BSI Scope Final Design Changes

Arup Final Design Kick-Off Meeting

November 7, 2017

Underground Communications

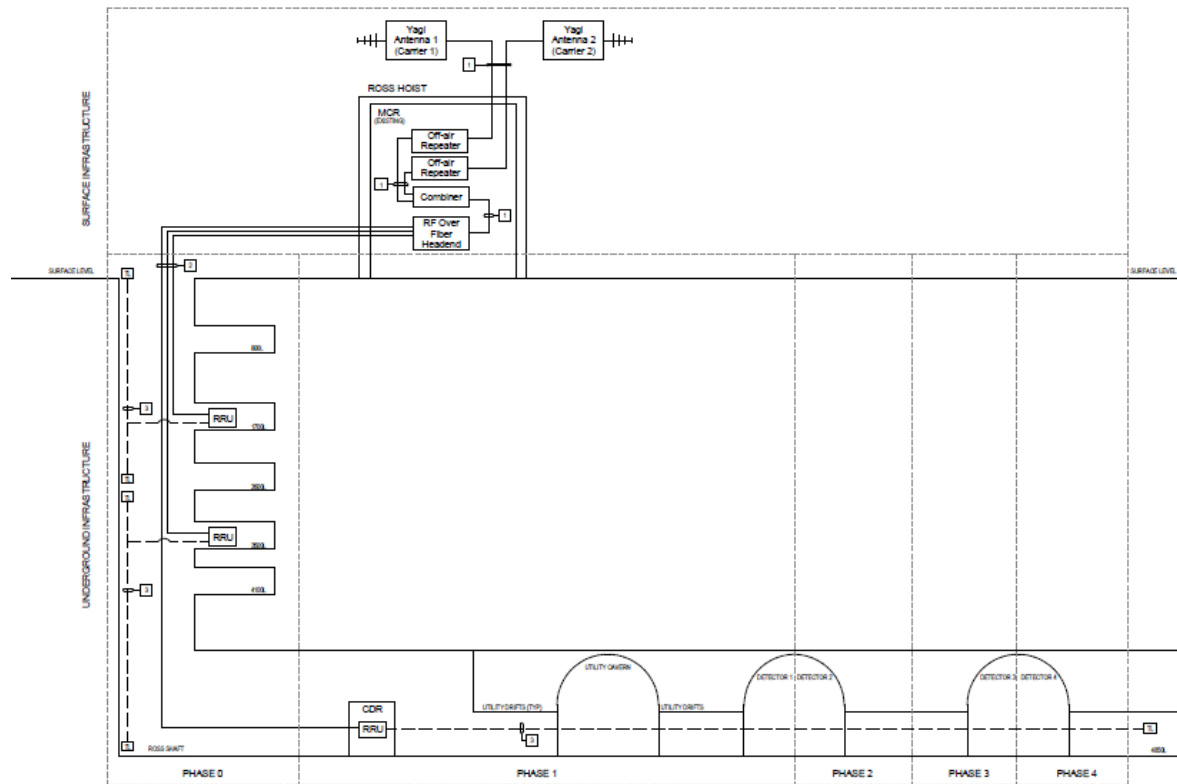
- Preliminary Design Scope for Leaky Feeder System – Scope Option
- Final Design Scope – To remain as a Scope Option

Surface Electrical

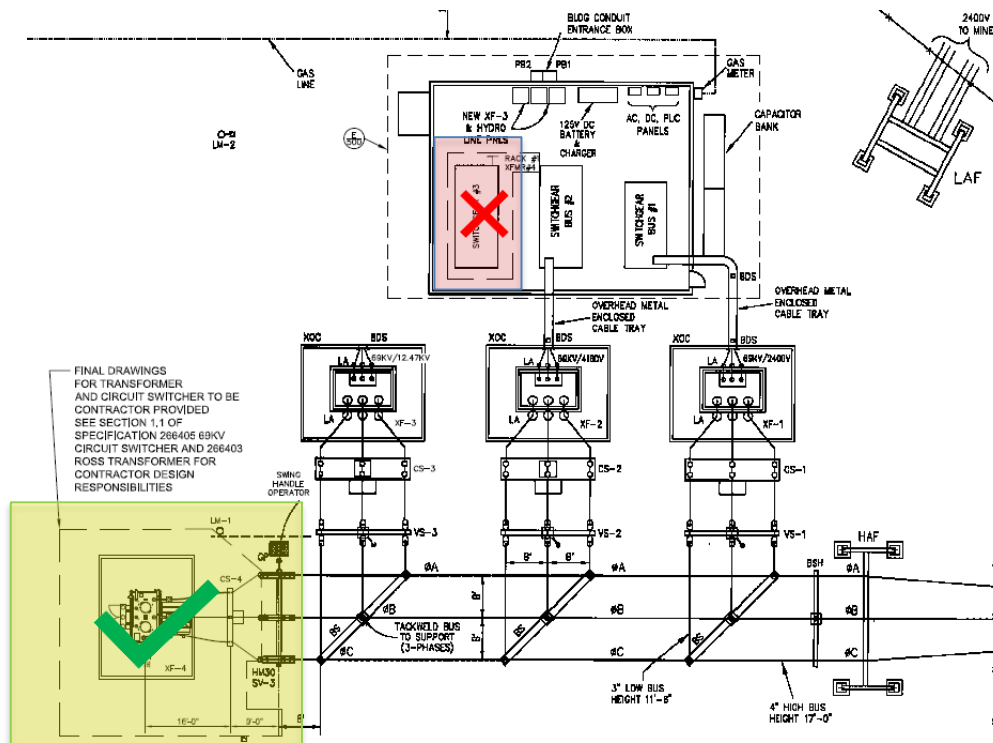
- Preliminary Design Scope for Surface Electrical included provision for design of Ross Surface Substation upgrades to be performed in Final Design
- Design for Ross Substation Upgrades has been completed in Pre-Excavation Final Design. Scope for Final Design requires inclusion of Costs for Transformer Installation in FD Cost estimate

Surface Mechanical

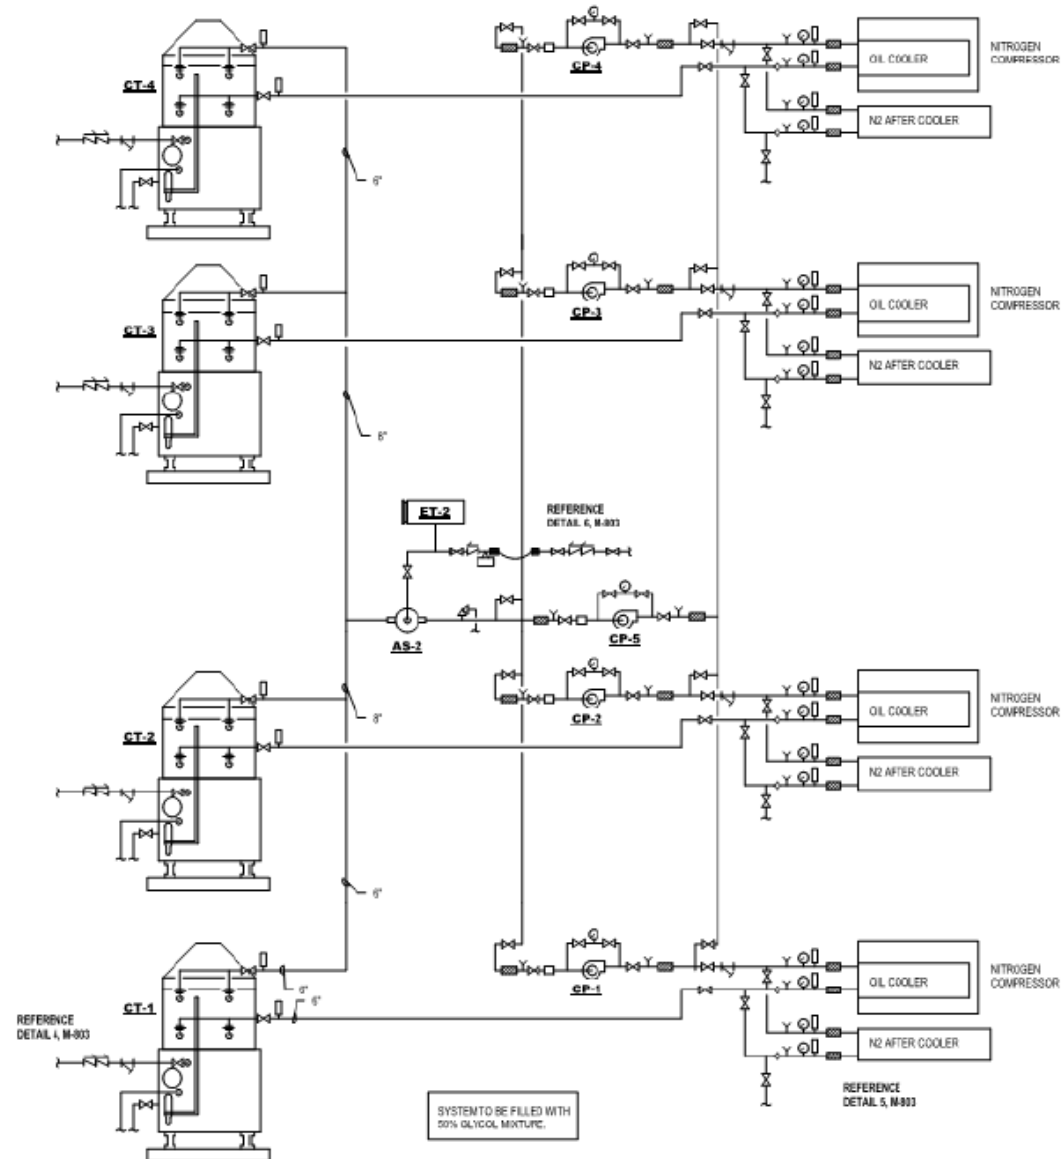
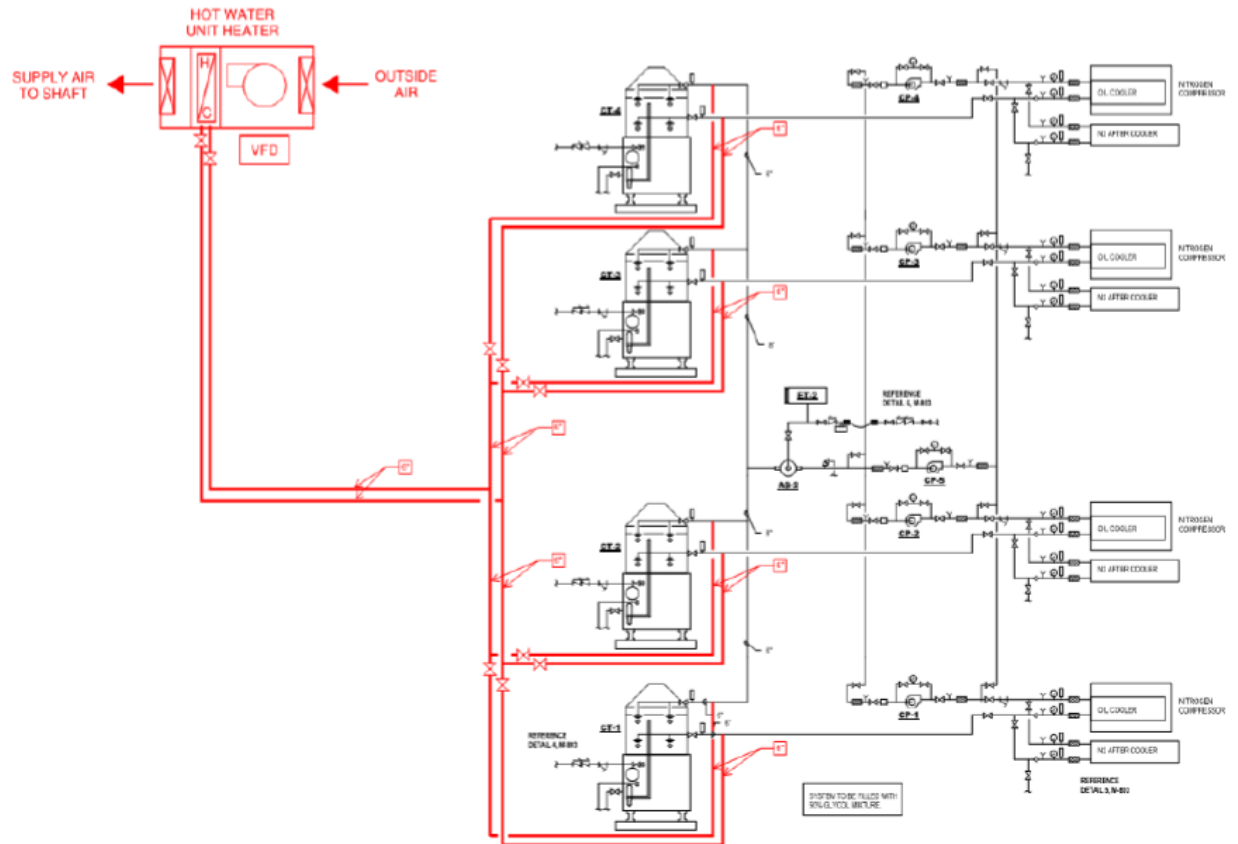
- Current Preliminary Design utilizes Cooling Towers for 100% Heat Rejection

- Incorporate the plan from the Advanced Preliminary Design task for utilization of waste heat from the Cryogen compressors to heat the Intake Air for the Ross Shaft
- Cooling Towers are to remain to provide cooling during warm periods where Shaft Intake air does not require heating

Surface Civil – Cryogen Building

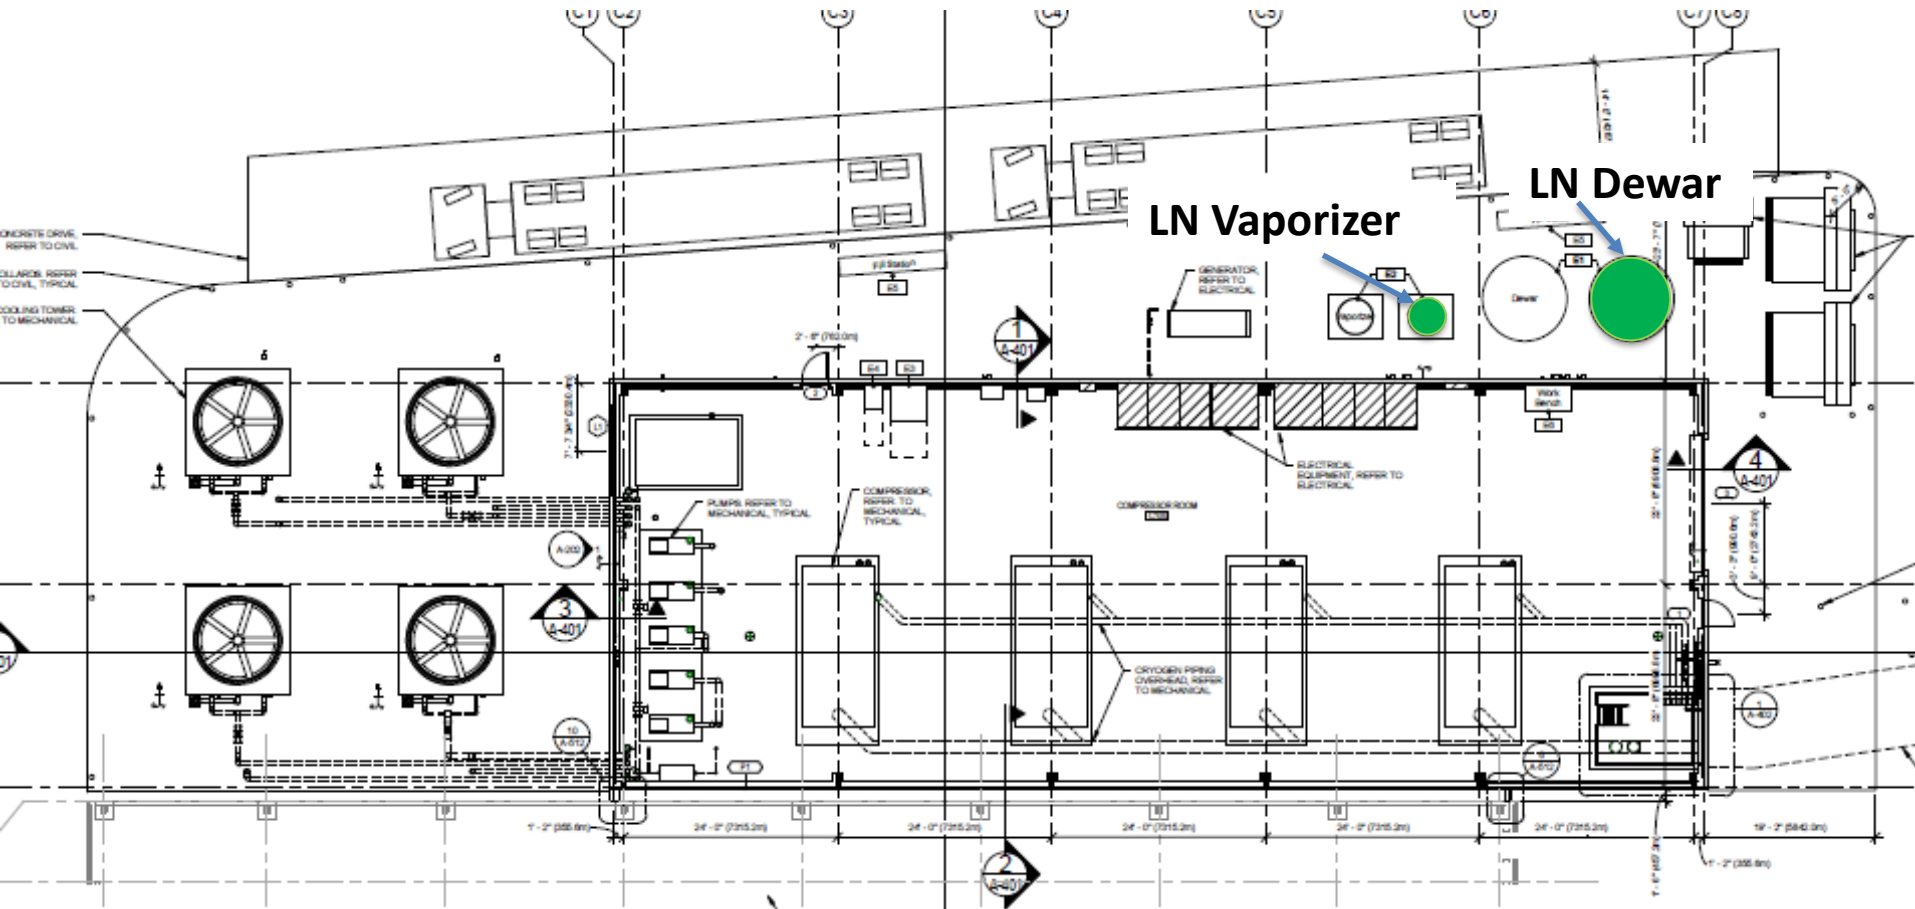
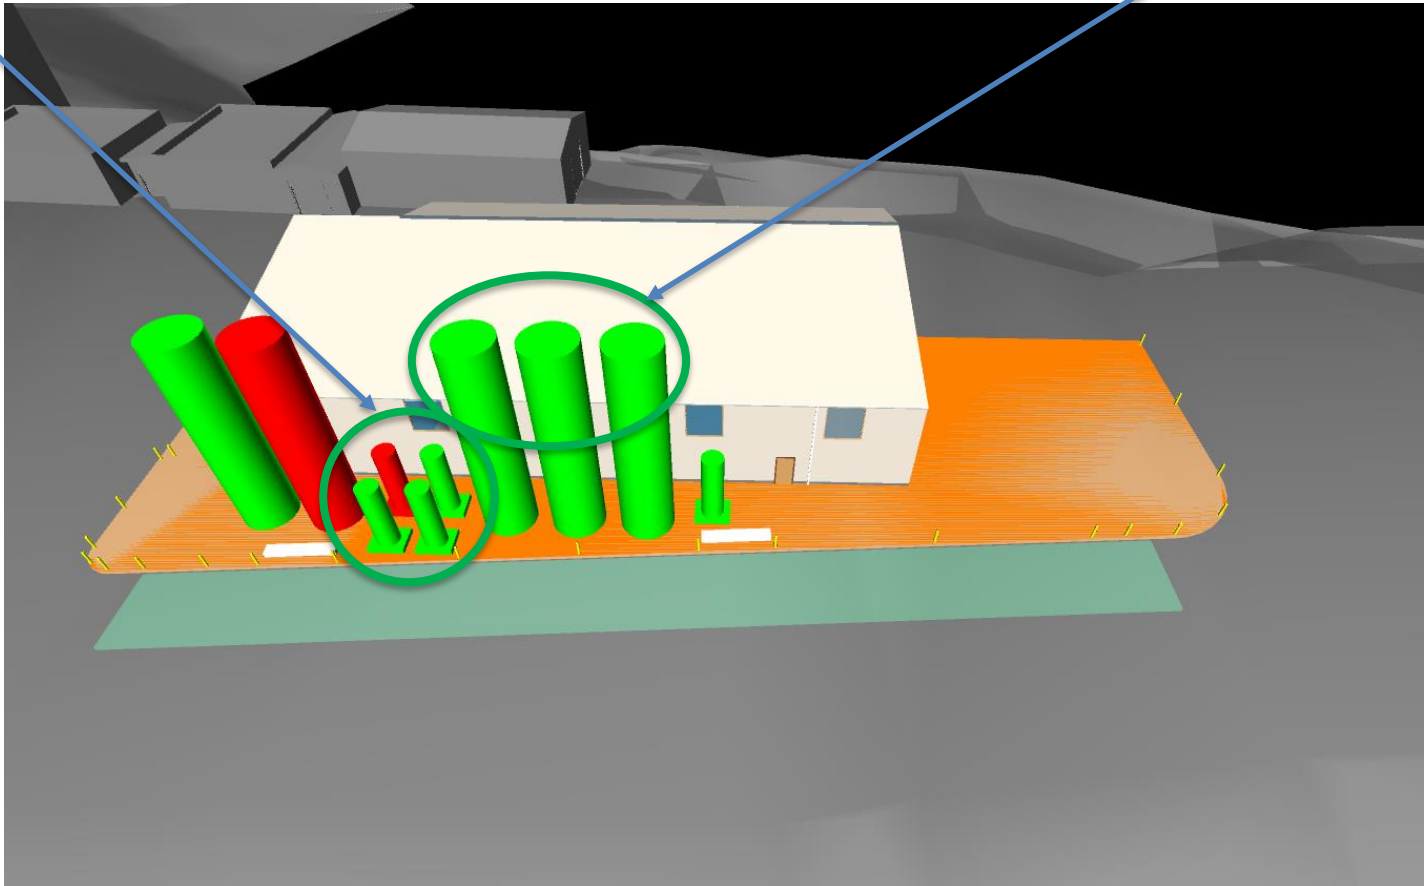
- Preliminary Design for the Cryogen Building considered only 1 Liquid Argon Storage Dewar and 1 Vaporizer

- Final Design for the Cryogen must incorporate an additional 3 Liquid Argon storage dewars into the design
- Also need 3 additional Liquid Argon Vaporizers

Ross Shaft Headframe Strengthening Design – Foundations

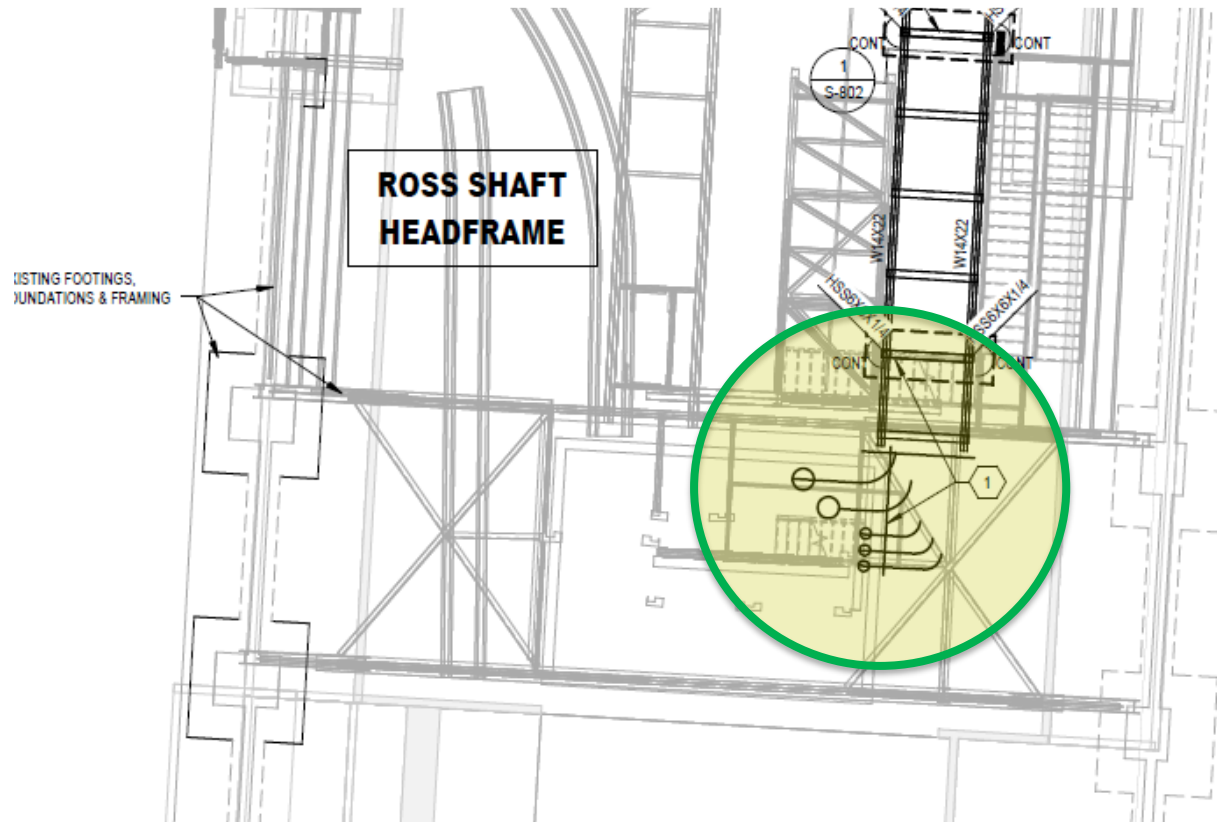
- Current design based on visual assessment
- Design update required that incorporates more extensive in situ testing. This testing will be performed as part of EXC which will inform the design update to be completed as part of BSI

Underground Electrical - Detector Electronics

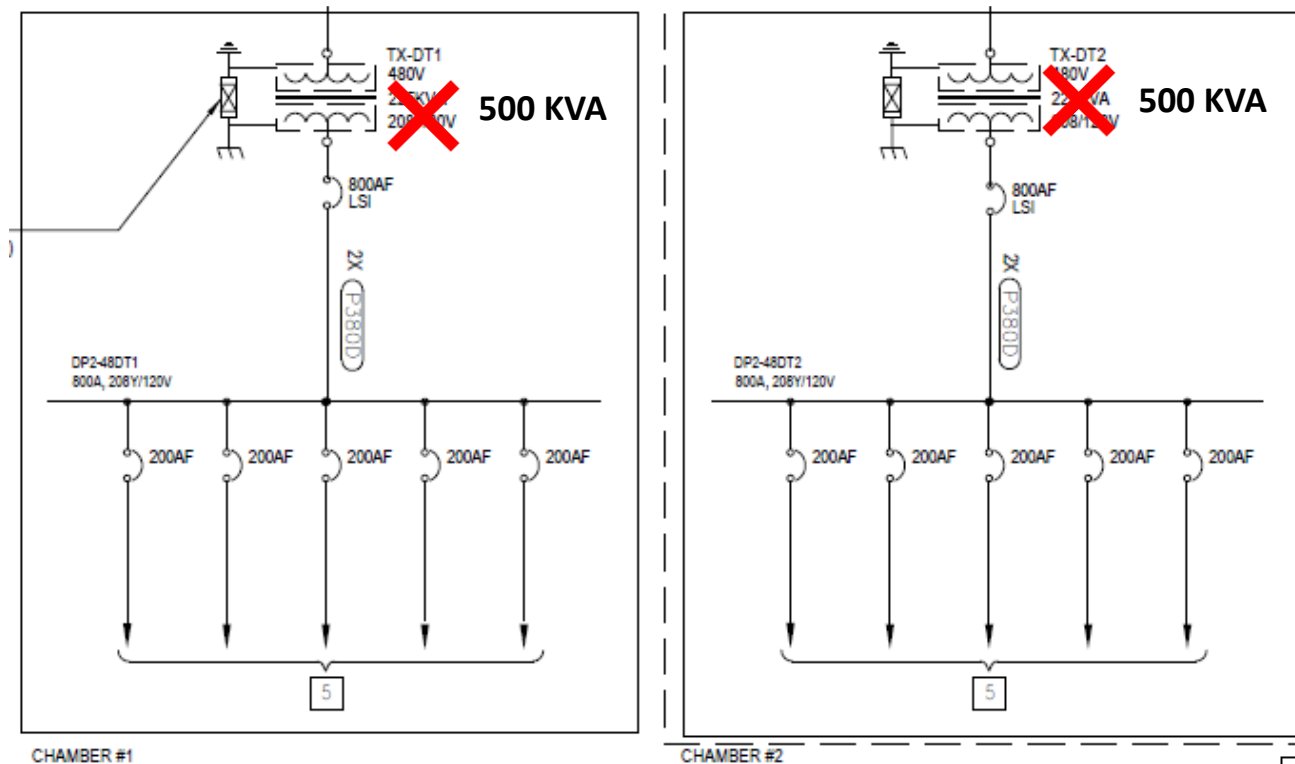
- Preliminary Design requirement for Detector Electronics – 225 KVA Transformers
- Final Design Change – 500 KVA Transformers
